AXOD/AXODE (AX4S) UPDATE HANDBOOK

*Updated
October, 2002*

Since the introduction of the Ford AXOD transaxle in model year 1986, there have been many major engineering design changes that have affected many of the parts used in the AXOD transaxle. This version of the AXOD "Update Handbook" begins with the 1986 model year and will explain each change, the parts affected by the change, and any parts interchange problems created by the change. This booklet is an updated version of the original.

Figure 37

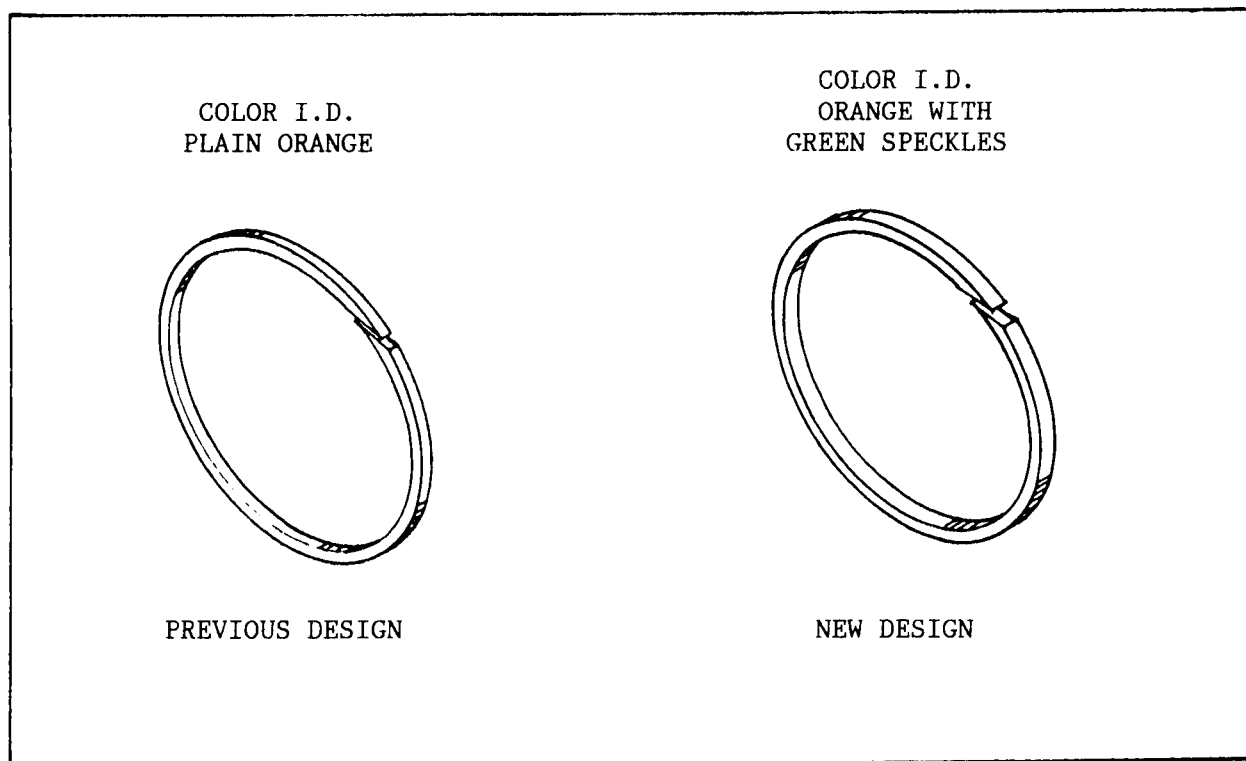
The five sealing rings on the driven sprocket support have been re-designed to help eliminate leakage in this area. The width of the sealing rings has been increased by approximately .015", and the new color identification is orange with green speckles (See Figure 37). The previous design sealing rings were plain orange in color.

The new design sealing rings are available under OEM number E6DZ-7D019-A, and should be used on ALL previous model AXOD transaxles.

Figure 38

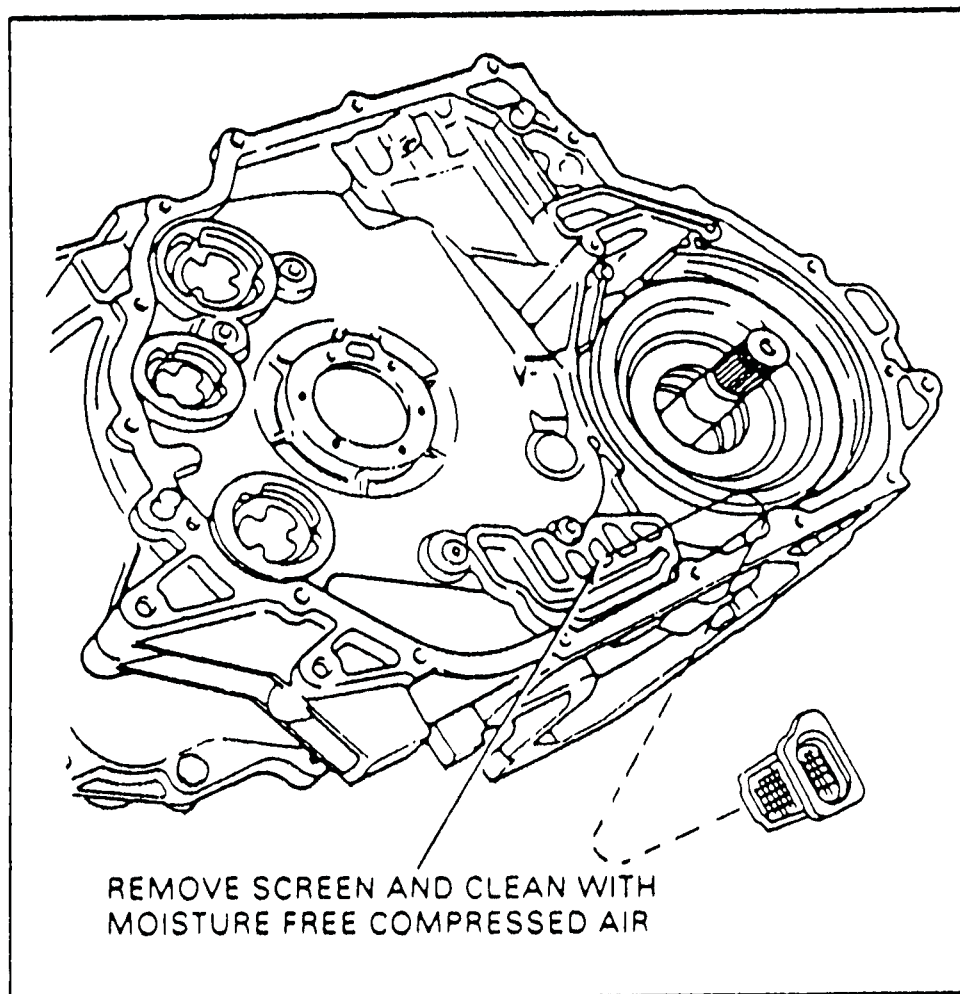
CHANGE: A new filter has been added to the 1989 AXOD 1-2 servo apply circuit as shown in Figure 38.

Figure 40

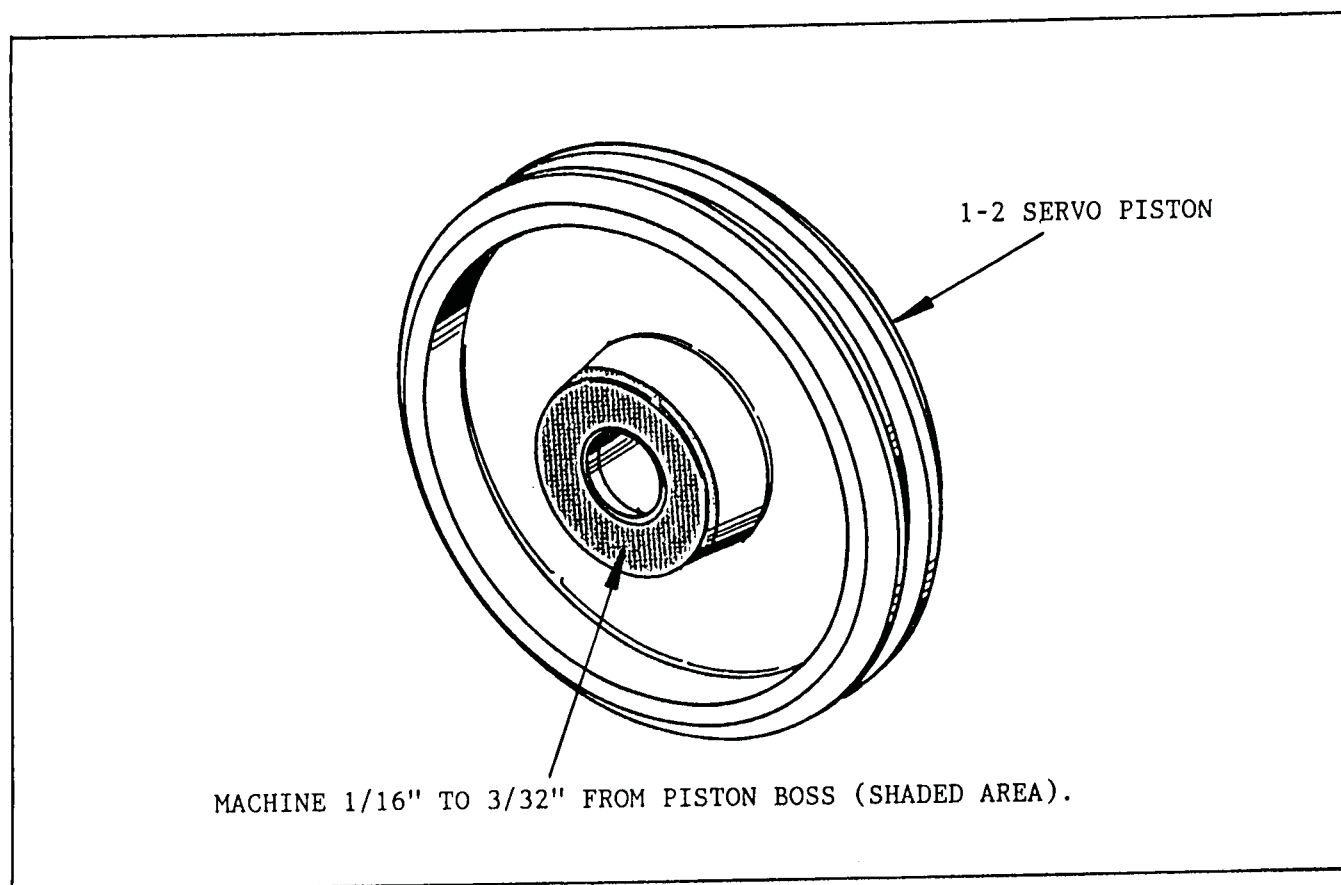
CAUSE: Insufficient travel of the 1-2 piston against the cushion spring.

CORRECTION: Remove 1/16" to 3/32" from the boss on the inside of the 1-2 servo piston as shown in Figure 40. We have shaded the area to be machined (See Figure 40).

Figure 41

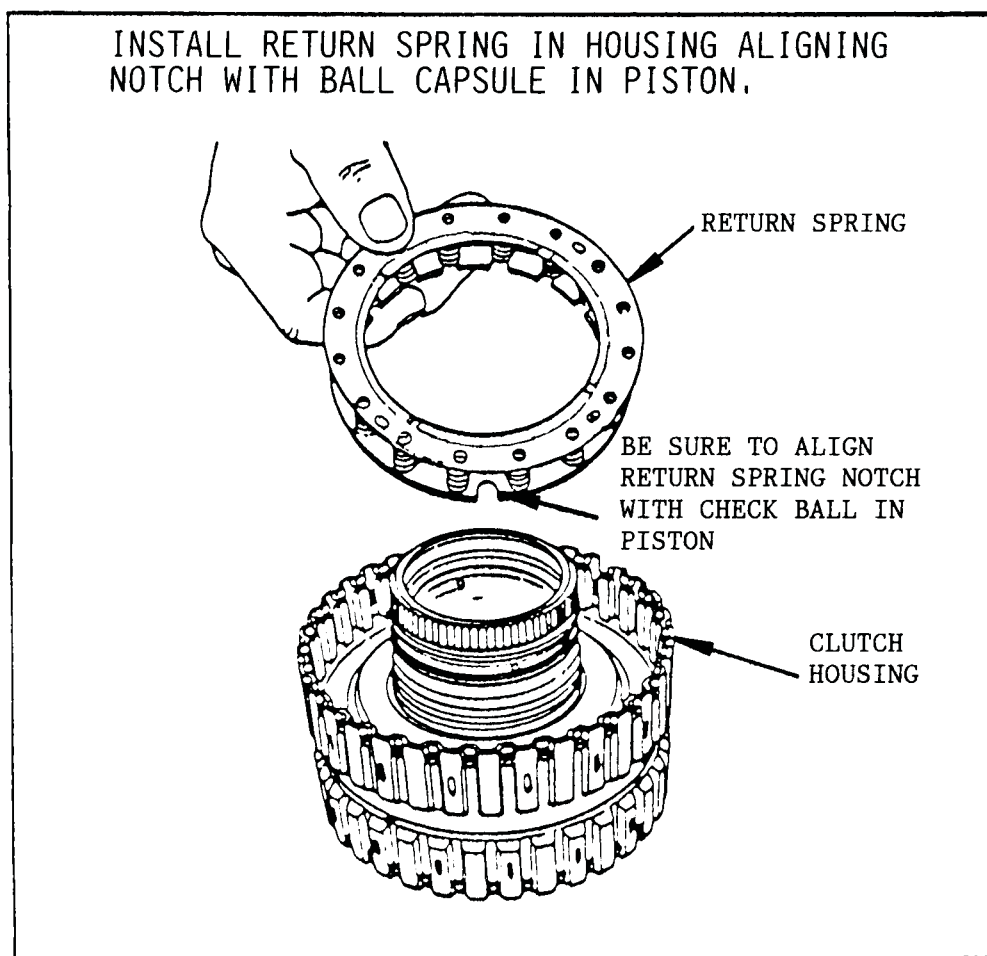
- COMPLAINT:** An extended 3-4 shift with possible direct clutch failure or a NO 3-4 shift condition.
- CAUSE:** This condition may be caused by a partially or fully blocked oil flow of the direct clutch piston check ball assembly.
- CORRECTION:** Special care must be taken during the overhaul operation when re-assembling the direct clutch return spring over the direct clutch piston. Make sure that the notch in the spring bottom retainer (See Figure 41) is positioned properly over the check ball capsule so as not to block or restrict oil flow of the check ball assembly. Refer to Figure 41.

Figure 43

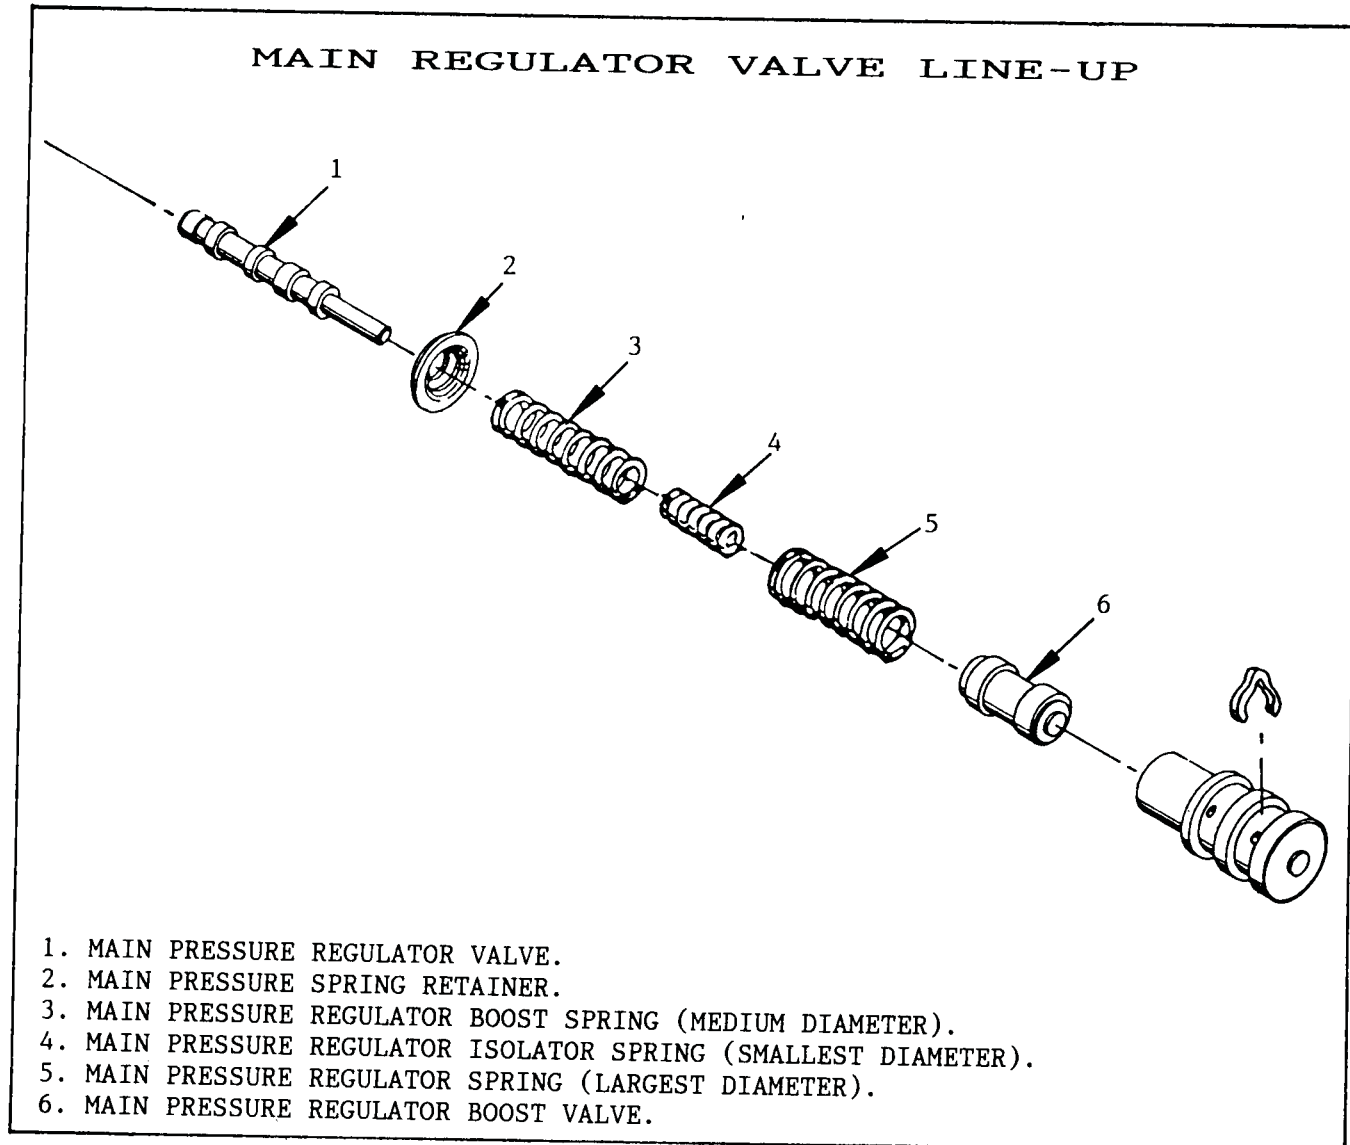
CAUSE: NO. 1. A "Shudder" during a 1-2 upshift will occur if the main pressure regulator "Isolator" spring is not installed after cleaning the valve body (See Figure 43). This is caused by fluctuations in main line pressure at the time of the 1-2 shift.

NO. 2. Delayed upshifts can be caused by the pressure regulator spring retainer being installed backwards (See Figure 43). This will create low main line pressure.

CORRECTION: NO. 1. Insure that all three (3) pressure regulator springs are re-installed in the valve body regulator bore (See Figure 43).

NO. 2. Insure that the main regulator spring retainer is installed in the proper direction (See Figure 43). The retainer is very similar to the one used in the AOD valve body, but is installed in the opposite direction of the AOD (See Figure 43).

Figure 44

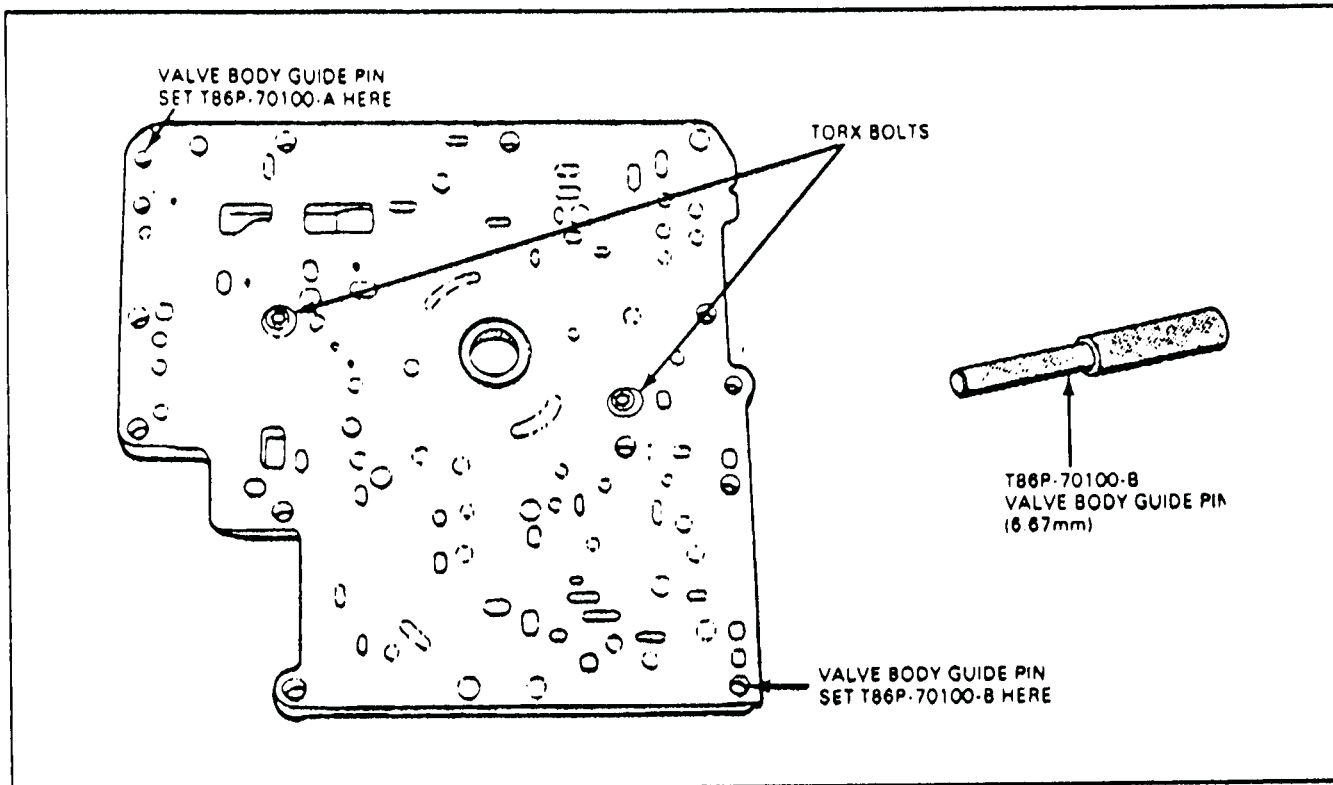
1. Position the spacer plate on the pump housing, using a new gasket.
2. Insert valve body guide pin T86P-70100-A (.271" Diameter) and valve body guide pin T86P-70100-B (.262" Diameter), as shown in Figure 44.
3. Install two "Torx" bolts and torque to 7 to 9 ft.lb.
4. Remove both guide pins.
5. Position the spacer plate on the valve body using a new gasket.
6. Insert two valve body guide pins T86P-70100-A (.271" Diameter, as shown in Figure 45.
7. Install two "Torx" bolts and torque to 7 to 9 ft.lb.
8. Position the oil pump on the valve body using a new gasket.
9. Insert pump body guide pin T86P-70370-A and valve body guide pin T86P-70100-C which is .245" in Diameter.
10. Install two valve body to oil pump retaining bolts and torque to 7 to 9 ft.lb.

Figure 48

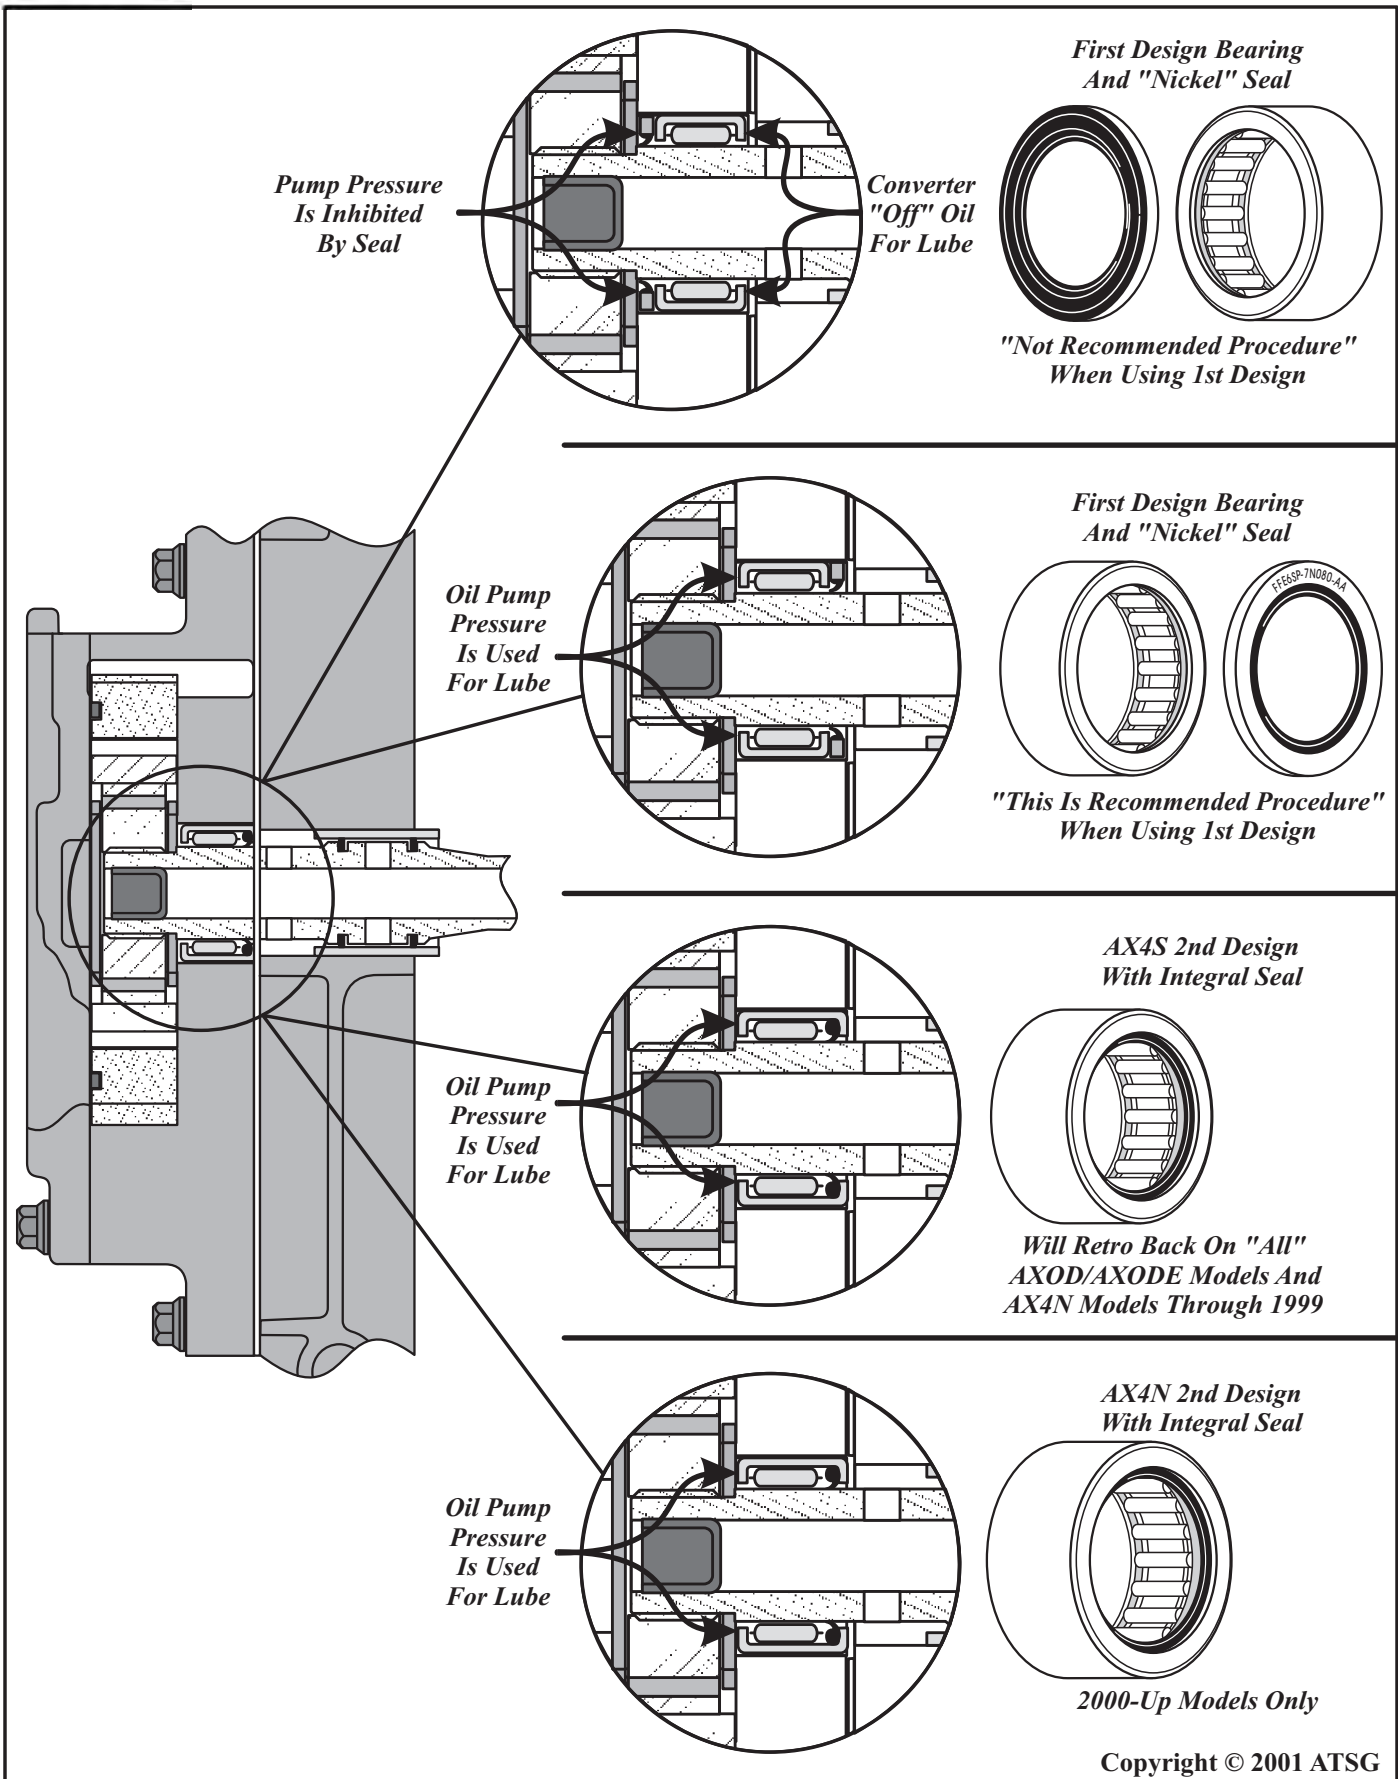
AXOD/AXODE (AX4S) - When using the 1st Design bearing with the "Nickel" Seal, install the seal on the valve body side, with the part number facing up, as shown in Figure 48. When using the 2nd Design bearing with the integrated seal, *which is recommended*, install the bearing assembly with the integrated seal facing the valve body side. The 2nd Design Bearing and Seal assembly *will retro-fit back on all* AXOD, AXODE and the AX4N up through 1999.
